JOINT REGIONAL PLANNING PANEL (Sydney West Region)

JRPP No	2013SYW023
DA Number	0453/12
Local Government Area	Ku-ring-gai Council
Proposed Development	Sydney Adventist Hospital - Construct 2 residential buildings (4 and 6 storeys) for student accommodation containing 126 studios, construct 2 residential buildings (4 and 6 storeys) for key worker accommodation containing 35 x 1 bedroom and 25 x 2 bedroom units (60 units), basement carparking, landscaping and stormwater works and subdivision - DA0453/12 lodged pursuant to the Minister of Planning Major Project Approval No.07_0166 MOD 4, Concept Plan for Wahroonga Estate (Precinct C: Central Hospital)
Street Address	185 Fox Valley Road, WAHROONGA
Applicant	Seventh-Day Adventist Church (Spd) Limited
Owner	Australasian Conference Association Limited
Number of Submissions	Twenty eight for original plans; two for amended plans
Regional Development Criteria (Schedule 4A of the Act)	The development application has a capital investment value of greater than \$20 million

185 FOX VALLEY ROAD, WAHROONGA – SUPPLEMENTARY REPORT

Figure 1 - Concept Plan approved section indicating dedicated shared footpath/cycleway (Figure 68, page 71, 'Wahroonga Estate Redevelopment Incorporating Sydney Adventist Hospital Final Preferred Project', January 2010)

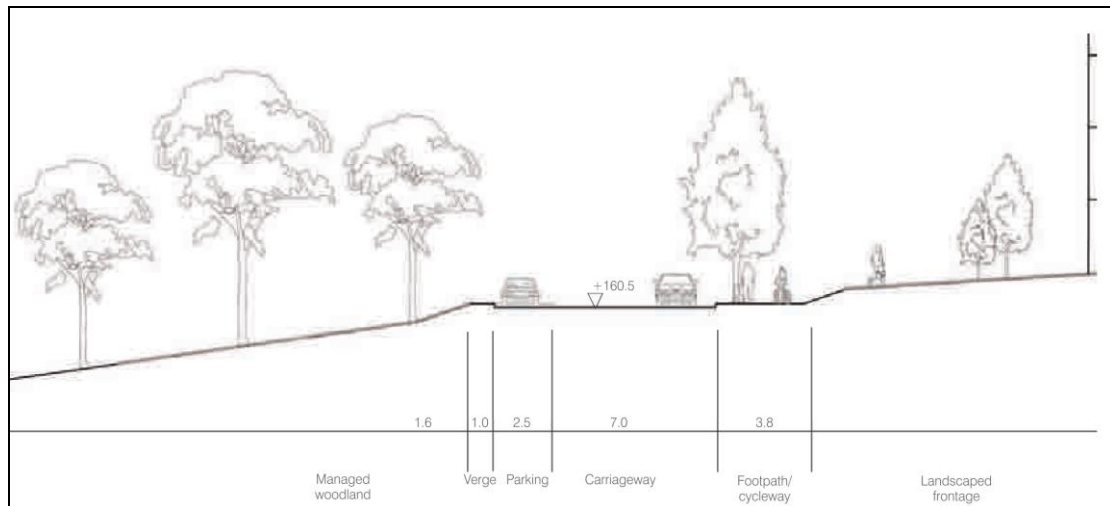
The applicant's response to this issue details an allocation of space and line-marking of a shared vehicle/bicycle network on the internal road, rather than a dedicated shared pedestrian/bicycle path along the site's northern boundary. As discussed below by Council's Strategic Transport Engineer and Urban Design consultant, this is inconsistent with the original Concept Approval. In particular, **Figure 1** (below) of the

approved Final Preferred Project & Concept Plan illustrates the street section within the main ring-road through the Estate as indicated in **Figure 2** (below) upon which the subject site is located. **Figure 1** clearly shows a dedicated pedestrian/cycle path separate to the vehicular carriageway and, as such, this formed the Concept Approval, rather than a shared vehicular/pedestrian/cycle path as is currently submitted by the applicant.

The applicant's response to this issue is inconsistent with the Estate Access Diagram (**Attachment I**) previously submitted by the applicant, which also indicates provision of a shared pedestrian and cycle pathway along the site's northern perimeter.

Council's Strategic Transport Engineer and Urban Design Consultant have commented on this issue in further detail below and it is recommended that a condition of consent be imposed to ensure provision of a dedicated path along the site's northern boundary (**Condition 3**). Provision of the dedicated pathway is required in order to deliver a system to encourage alternative transport and reduce car dependence and reinforce the living-working community environment as envisaged by the Concept Approval.
